| Project No. | Zone Changes 2004Z-113U-02 and |

| Project No. Project Name Associated Cases Council Bill Council District School District Requested By Deferral | Planned Unit Development 2005P-010G-02 Nashville Commons at Skyline 2004Z-113U-12, 2004Z-115G-12, and 88P-056G-02 None 3 - Tucker 3 - Garrett Gresham Smith and Partners, applicant for Sallie R. Hicks Family LLC, Bandy, Carolene and Alice Cranford, Pegasus Properties, and Jenkins Properties L.P. and Jack Jenkins, owners Deferred indefinitely at the March 10, 2005, Commission meeting, with the public hearing kept open |

| Project No. Project Name Council Bill Council District School District Associated Cases Requested By Deferral Staff Reviewer Staff Reviewer | Planned Unit Development 88P-056G-02 Mulberry Downs PUD None 3- Tucker 3 - Garrett 2004Z-115G-12, 2004Z-113U-12, and 2005P-010G-02 Gresham Smith and Partners, applicant for George Hicks Family Trust, owner Deferred indefinitely at the March 10, 2005, Commission meeting, with the public hearing kept open Pereira Approve with adoption of associated PUD (2005P- 010G-02) |

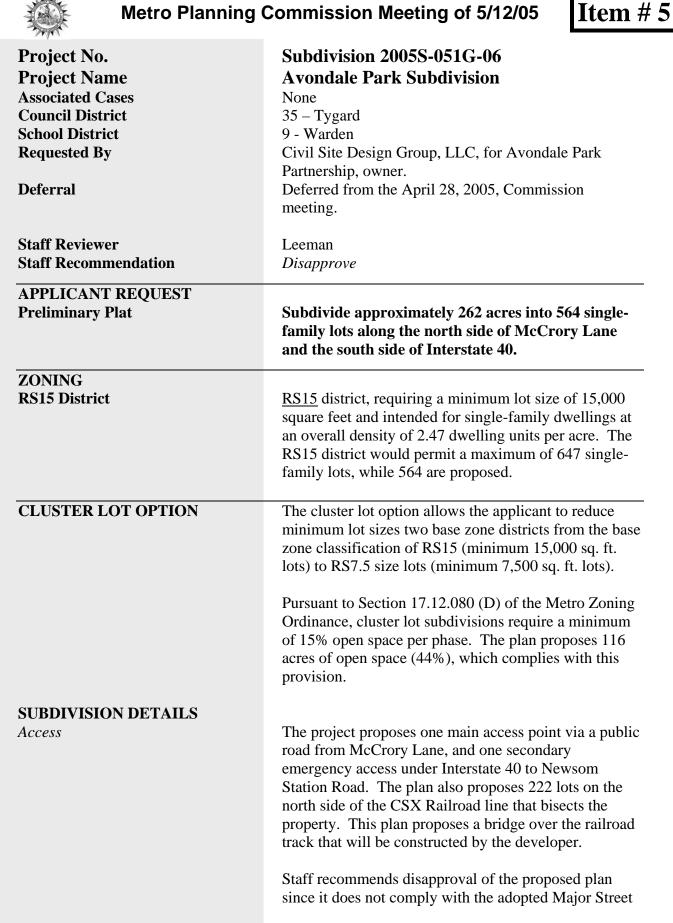
15. Note that to comply with the above Stormwater requirements, it is required for the applicant to put the following notes on the preliminary PUD plans:

"Any intermittent stream or waters of the state, as identified by TDEC, shall have a 25 foot buffer from the top of the bank on each side of the stream bank."

"Buffer disturbance is ONLY permitted by Stormwater Management Committee variance # _____ and ARAP Permit # _____."
